Draft Panel Questions (8 Questions)
Absorb GT1™ Bioresorbable Vascular Scaffold (BVS) System

Evaluation of Safety and Effectiveness

Figure 1: Target lesion failure rates from the last available follow-up of the BVS randomized trials

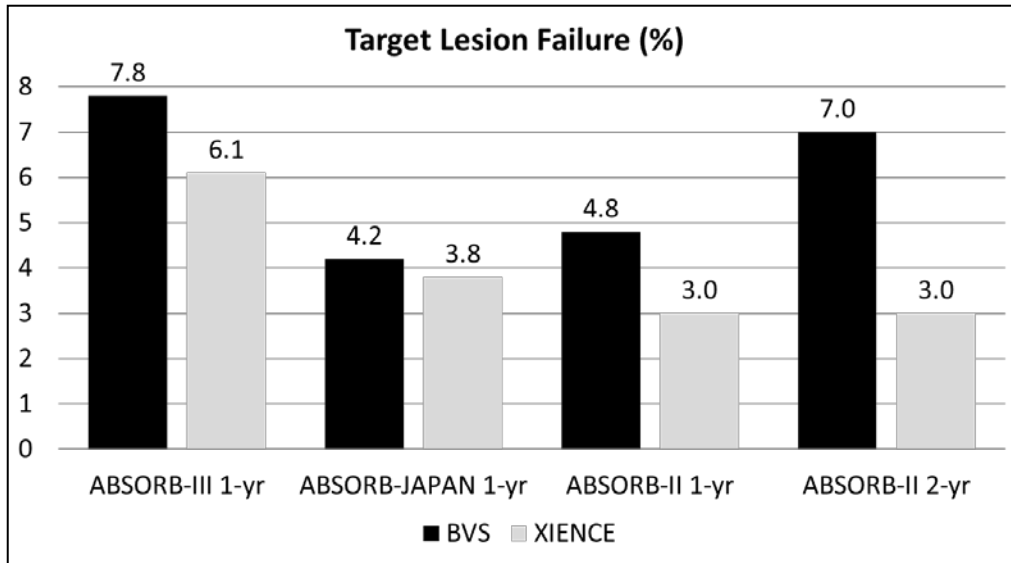
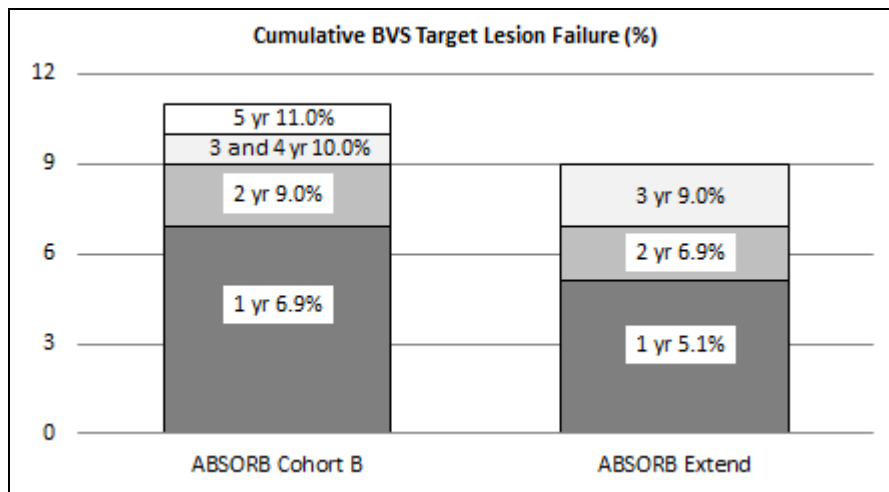
Q5: Please comment on whether or not the PMA includes adequate follow-up data in a sufficient portion of the patient population identified in the proposed indications to support safety and effectiveness. If the duration of follow-up is insufficient, please comment on how much additional follow-up data from the ABSORB III trial should be provided to demonstrate a reasonable assurance of BVS safety and effectiveness.
